Access Compliance Report Public Rights-of-Way (Curb Ramps)

Main Street: COMET_TRAIL Cross Street: COMET_TRAIL Location: E

ADA ID: RPAT211101102742 Ramp Type: Type 4 - Parallel Initial Pass/Fail: Fail Overall Compliance: No Severity Score: 16

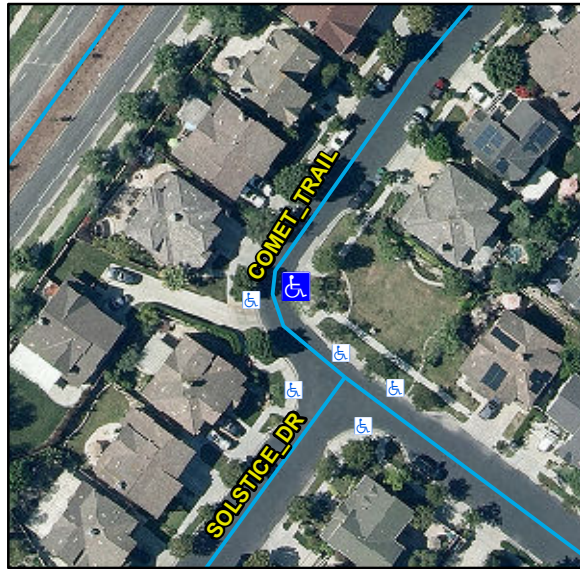
R204.3, R304.3.2, R304.5.3, STD 1115

Compliance	Description	Data	Compliance	Description	Data
N/A	Ramp Length LT (in)	110	N/A	Ramp Length RT (in)	102
Yes	Ramp Width LT (in)	53	Yes	Ramp Width RT (in)	54
No	Ramp Run Slope LT (%)	9.2	Yes	Ramp Run Slope RT (%)	2.1
No	Ramp Cross Slope LT (%)	2.7	No	Ramp Cross Slope RT (%)	2.3
N/A	Landing Present	N/A	N/A	DWS Provided	N/A
N/A	Landing Length (in)	N/A	N/A	DWS Contrast	N/A
N/A	Landing Width (in)	N/A	N/A	DWS Length (in)	N/A
N/A	Landing Run Slope (%)	N/A	N/A	DWS Full Width	N/A
N/A	Landing Cross Slope (%)	N/A		DWS Offset Type	N/A
N/A	Landing Movement Obstructed?	N/A	N/A	DWS Offset Left (in)	N/A
	Landing Movement Type	N/A	N/A	DWS Offset Right (in)	N/A
N/A	Landing Shared	N/A			
N/A	Clear Space	N/A			
N/A	Clear Space To Crosswalk (in)	N/A			
N/A	Marked Crosswalk 1	No	N/A	Marked Crosswalk 2	N/A
	Crossing 1 Direction	NW		Crossing 2 Direction	N/A
	Marked Crosswalk 1 Width (in)	N/A		Marked Crosswalk 2 Width (in)	N/A

Remove & Replace Entire Ramp.
